SERVICE BULLETIN

REPUBLIC AVIATION CORPORATION
FARMINGDALE, LONG ISLAND, NEW YORK
SERVICE DEPARTMENT

SERVICE BULLETIN NO. 9

REWORK OF STARTER TERMINAL JUNCTION COVER ASSEMBLY

Figure 1

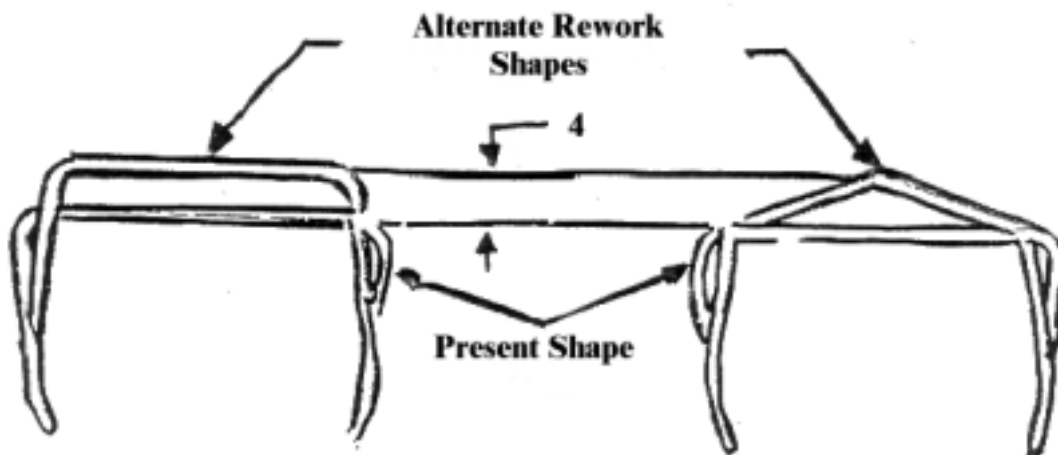
Reason for Change: To prevent the possibility of a short circuit occurring if the cover becomes dented.

Description of Change: This change involves removing the starter terminal junction cover located forward on the firewall and bending it to give sufficient clearance; the rework shall be accomplished as follows:

1. Remove top and right hand side cowl.
2. Remove starter terminal junction cover and rework as shown on Figure 1 by bending.
3. Replace junction cover, top and right hand side cowl and make suitable entry in log book.
